RE: West Mamm Creek Pipeline Project Objection

Please consider this objection to the Draft Decision Notice (DDN) and Environmental Assessment (EA) for the West Mamm Creek Pipeline Project #64353.¹ The project is proposed on the White River National Forest (WRNF), within the Rifle Ranger District. The Forest Supervisor is the deciding officer for this project. This objection is timely filed on behalf of Western Watersheds Project, Wilderness Workshop, Center for Biological Diversity, Western Colorado Alliance, Save West Mamm Creek, Colorado Sierra Club, Roaring Fork Audubon, and ColoradoWild (hereafter “the objectors”). The objectors previously submitted comments relevant to issues discussed below which can be found in the project record.

Diagram 1

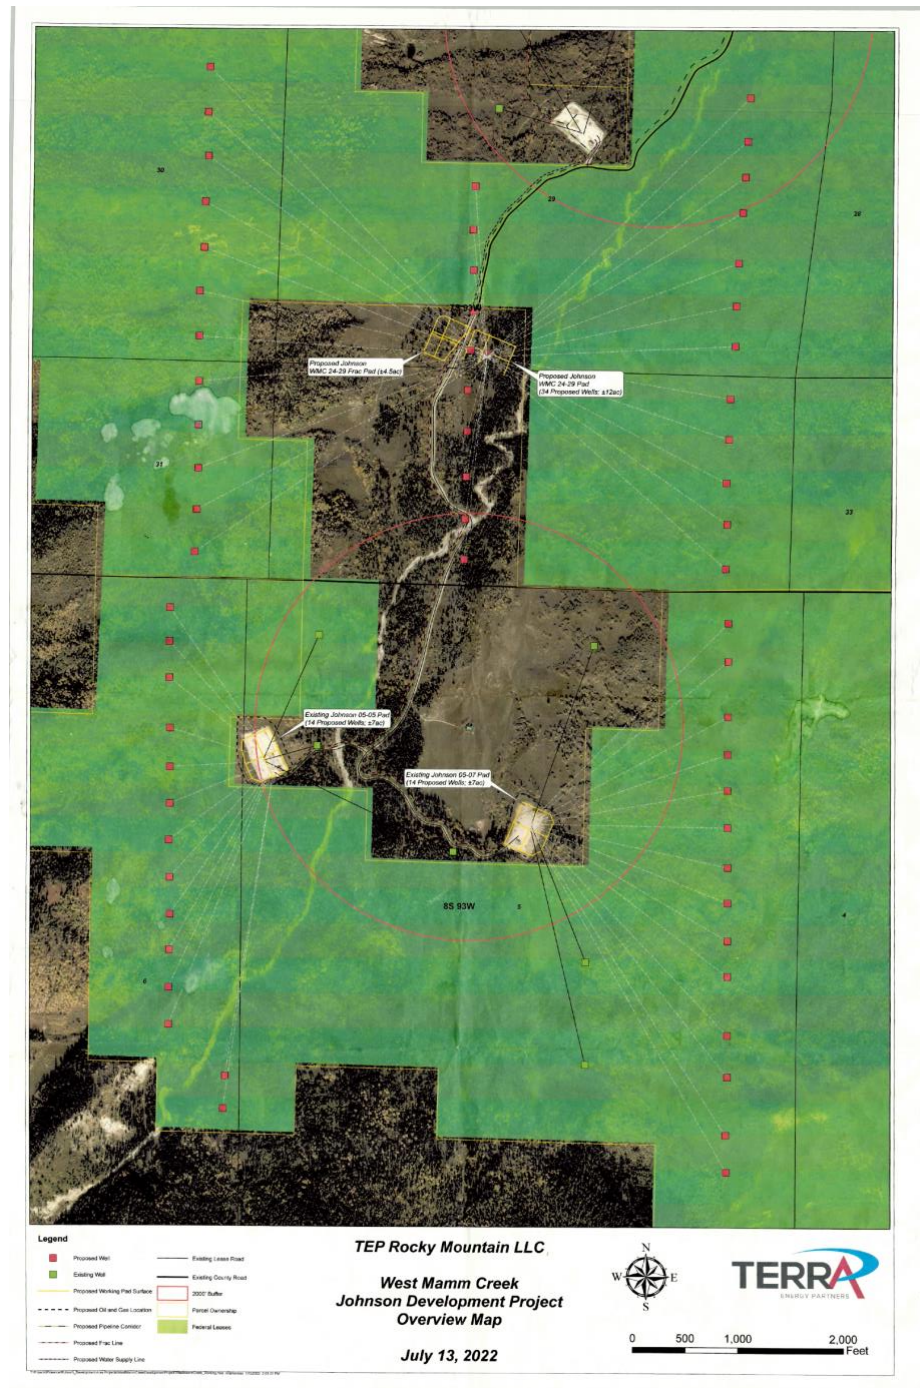
Still more documentation of future development in excess of the 47 wells analyzed in the EA is exhibited below in Diagram 1. Diagram 1 shows TEP’s proposal to directionally drill, complete, and operate sixty-two (62) natural gas wells from three (3) oil and gas pads located on private surface formerly owned by Johnson, RM Revocable Trust. See also TEP, West Mamm Creek Phase 2 Plan of Development Summary (August 2022) (attached as Exhibit 4) (describing in detail the TEP drilling plan depicted in Diagram 1). The Johnson property recently changed hands and is now owned by Lulu Colby. An email between the current property owner and TEP representatives on April 21, 2025 shows that the company’s plans have not changed. See email from Bryan Hotard, TEP to Lulu Colby (April 21, 2025) (attached as Exhibit 5).
